**DELEGATED AUTHORITY CONSULTATION REPORT 7508**

**TRAFFIC ORDERS – 30 GROSVENOR SQUARE (FORMER AMERICAN EMBASSY)  
(Drawing Nos. 70032286-TMO-02 and 7508/JH)**

**(West End Ward)**

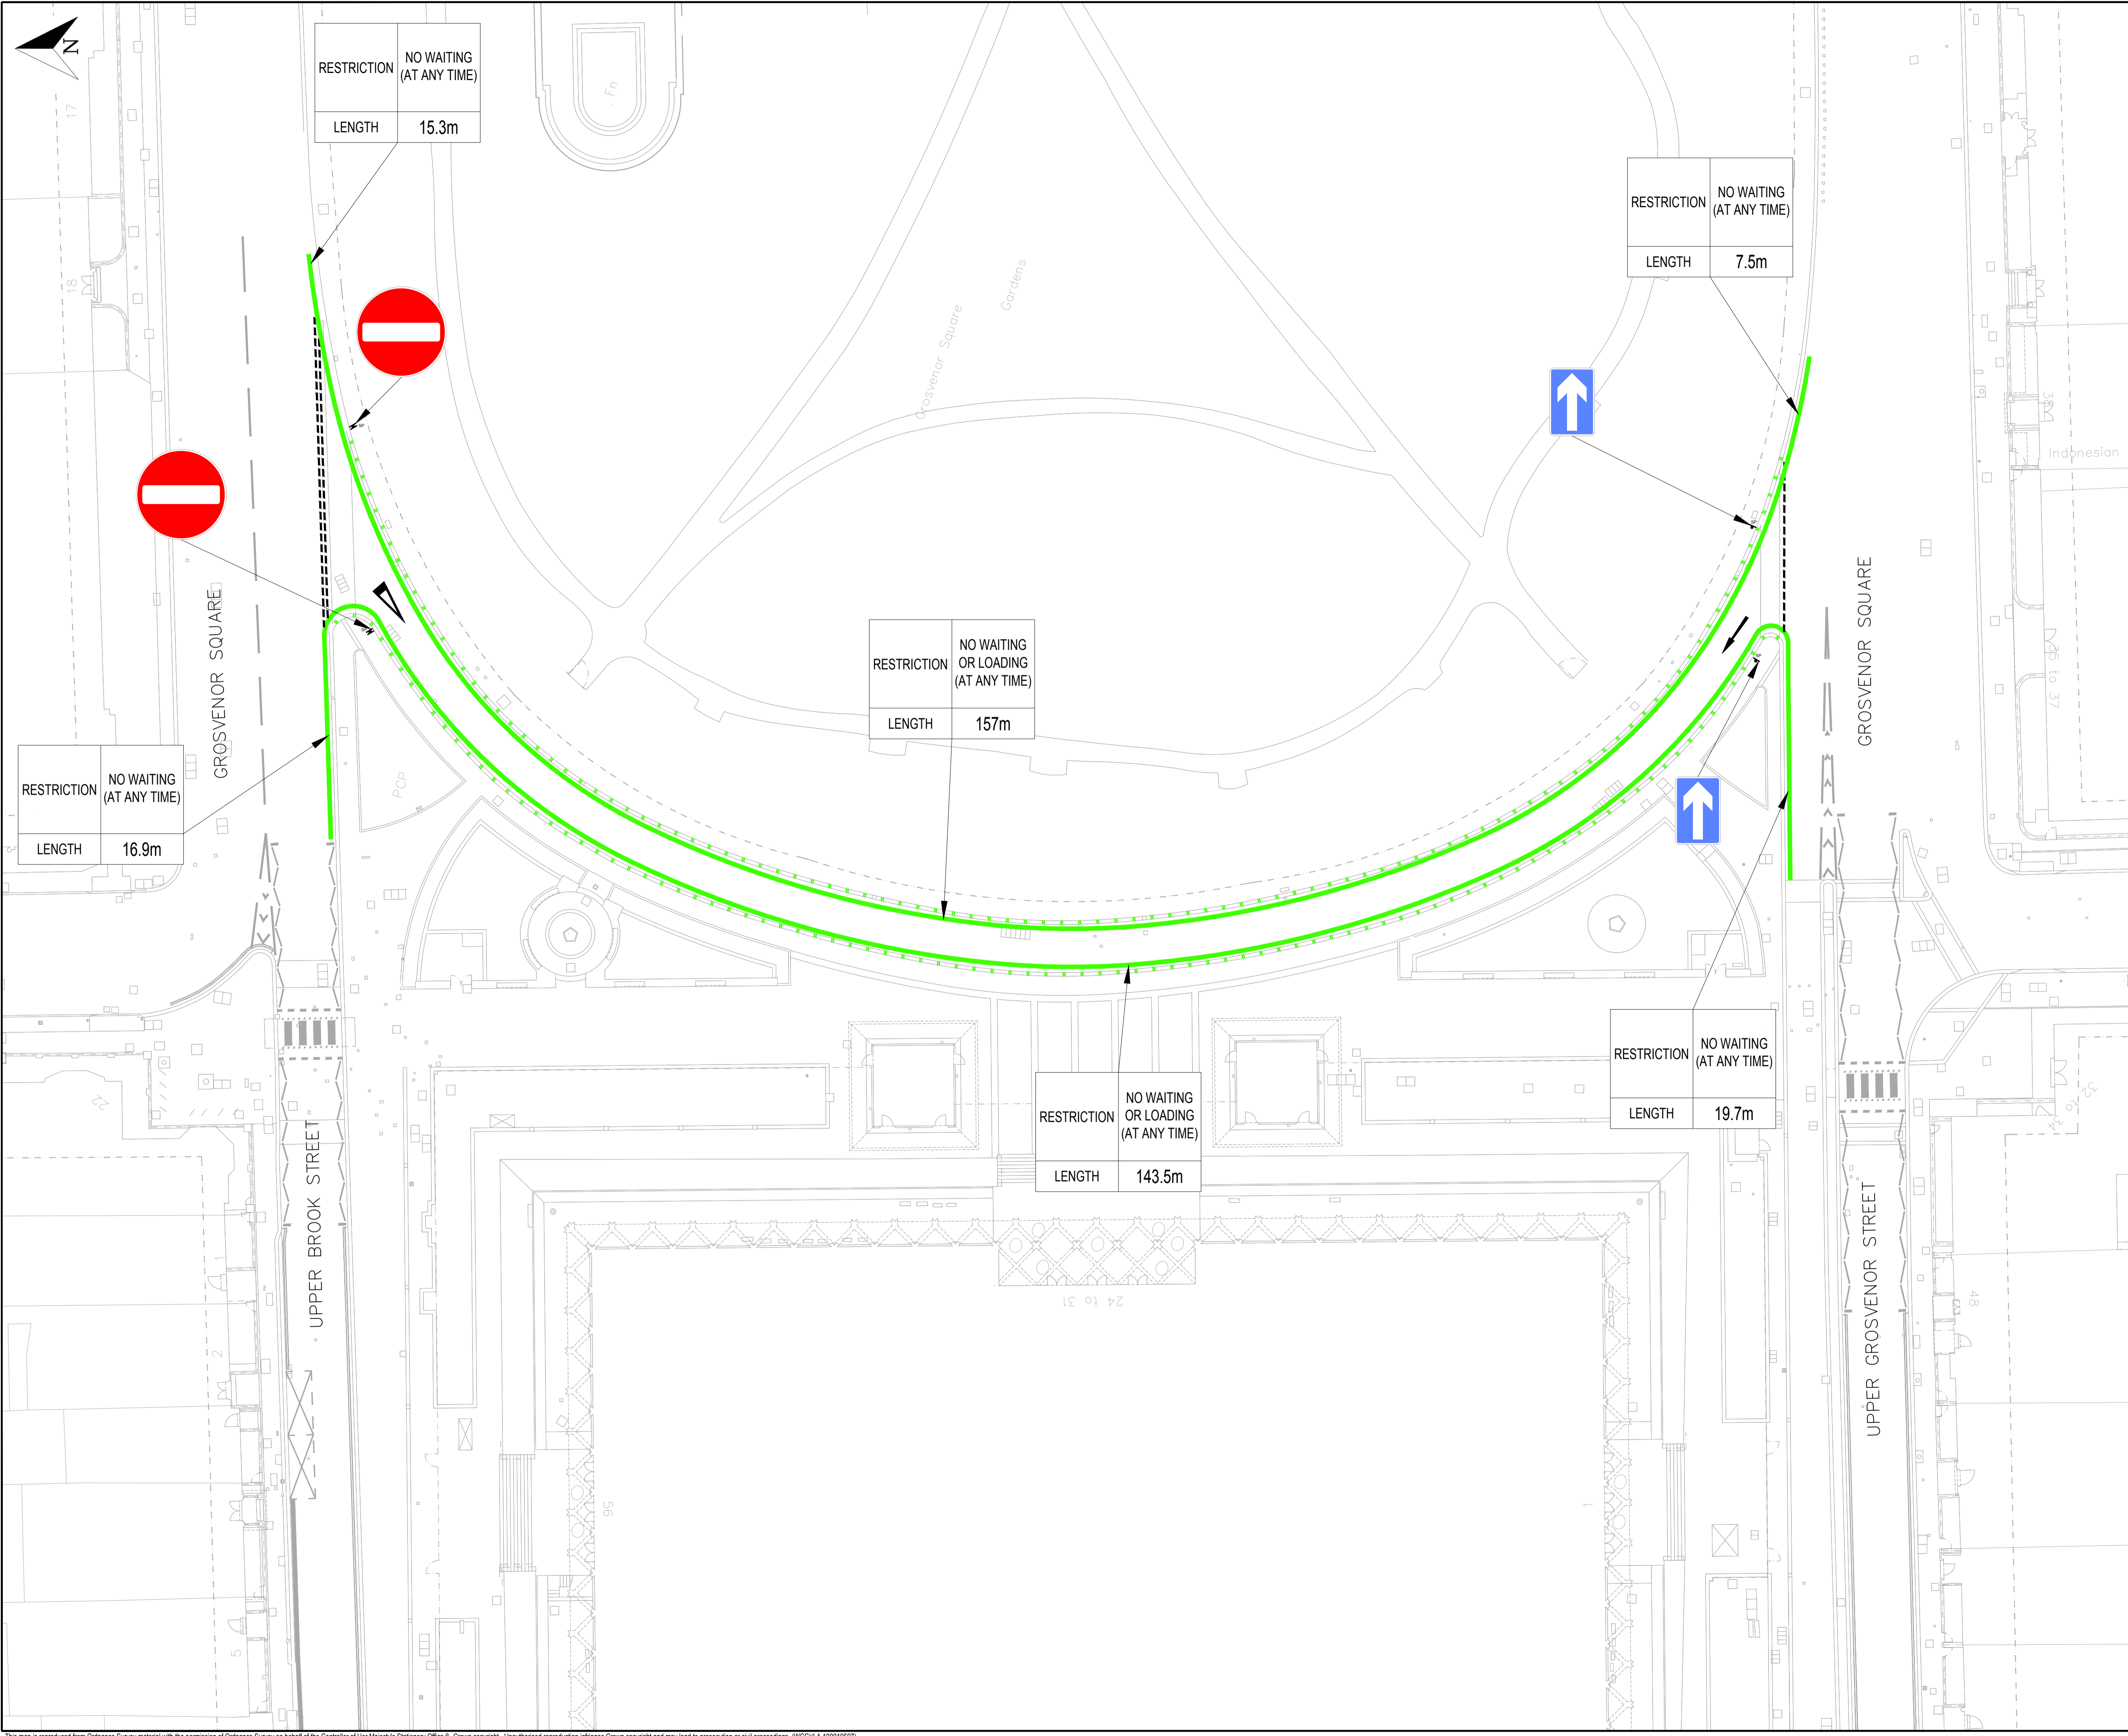
GROUNDS OF OBJECTION	OFFICERS' COMMENTS
<b>1. Lack of parking facilities</b>	
<p>Insufficient resident's parking facilities have been provided in Blackburne's Mews. Many households have more than one vehicle and the proposals would prevent residents from parking outside their homes.</p>	<p>The City Council's Parking Services Team identified the most viable locations to introduce parking facilities in Blackburne's Mews, without blocking access to garages and causing obstruction, and to prevent indiscriminate parking.</p> <p>The residents' permit parking scheme entitles the permit holder to park in any residents' bay within E Zone. However, the scheme does not guarantee that a parking place will be available close to a residents' home. Residents of Blackburne's Mews will be able to utilise the parking facilities in adjacent streets, such as Culross Street, Upper Brook Street and Upper Grosvenor Street.</p> <p>Residents' displaying a residents' parking permit can also park in pay-by-phone bays in E Zone free of charge for the first hour and last hour of the parking controlled hour (i.e. before 9.30am and after 5.30 p.m. on Mondays to Saturdays).</p>

<b>2. Residents' parking provided along entire west side</b>	
<p>Residents' parking should be designated along the entire west side of Blackburne's Mews with double yellow line "at any time" waiting restrictions at appropriate locations (such as garage entrances). This would allow for residents to park outside their homes and prevent construction workers from parking their vehicles in the street.</p>	<p>It is not possible to provide any additional parking spaces on the west side of Blackburne's Mews. The proposed layout provides the maximum number of parking spaces that can be achieved for ensuring that access to off-street parking is unhindered, and the double yellow lines will prevent the indiscriminate and obstructive parking that is currently taking place because of lack of road markings and formal controls.</p>
<b>3. Individually allocated parking spaces</b>	
<p>Specific residents' bays should be allocated to house numbers to allow residents to park close to their homes.</p>	<p>The City Council's residents' permit parking scheme does not allow for residents' parking bays to be allocated to specific households, regardless of the fact that there is simply not enough available space to accommodate this. Each bay would have to be individually signed which would create excessive street clutter, and such a scheme would remove the flexibility to use vacant spaces within the vicinity. The costs of administering and enforcing such a scheme would also be prohibitive.</p>

GROUNDS OF OBJECTION	OFFICERS' COMMENTS
<b>4. Parking in the vicinity of the Embassy of the Principality of Monaco</b>	
<p>Concern that vehicles using the proposed residents' parking place outside Nos. 7 and 8 Blackburne's Mews could infringe on the Embassy of the Principality of Monaco's access to and egress from their garage at that location.</p> <p>The addition of double yellow line "at any time" waiting restrictions would hinder the transport functionality of the Embassy of the Principality of Monaco in terms of official visits and contractors. The Embassy has requested that a diplomatic parking bay be provided in Blackburne's Mews as a mitigating measure.</p>	<p>It is not considered that the introduction of the residents' parking place outside Nos. 7 and 8 will have a detrimental effect on access to the Embassy's off-street parking facilities. However, the City Council will monitor the impact of the parking layout after implementation and, if necessary, revise the accordingly.</p> <p>The provision of double yellow line "at any time" waiting restrictions is likely to improve transport functionality as vehicles will be prevented from parking in Blackburne's Mews (except for permit holders in designated parking places) leaving the area clear for deliveries and the picking up / setting down of passengers.</p> <p>Diplomatic bays are provided based on the number of accredited Diplomats and the availability of off-street parking facilities. Therefore, the City Council does not consider that the Embassy meets the criteria for a dedicated diplomatic bay to be provided in Blackburne's Mews.</p>

<b>4. Motorcycle Parking</b>	
<p>The motorcycle parking place will only be utilised by employees of the hotel (once opened). This space would be better served as residents' parking.</p>	<p>It is not possible to accommodate a standard 5 metre residents' parking bay at the location of the motorcycle bay as it would obstruct the entrance to the gardens in Blackburne's Mews.</p> <p>Previous surveys in Blackburne's Mews have identified motorcycles parked informally. It is therefore assumed there is a demand for motorcycle parking at this location and, as such, a formal 3.5 metre motorcycle parking bay is proposed as part of the scheme.</p> <p>If the motorcycle bay is under-utilised, the parking layout will be reviewed.</p>
<b>5. Rat-running</b>	
<p>How will the City Council prevent Blackburne's Mews being used as a 'rat-run' by vehicles travelling between Upper Brook Street and Upper Grosvenor Street?</p>	<p>Since the removal of the security measures associated with the former US Embassy, Blackburne's Mews and Culross Street have reverted to being "regular" public highway. As a result, both streets have been open to vehicular traffic for several months.</p>
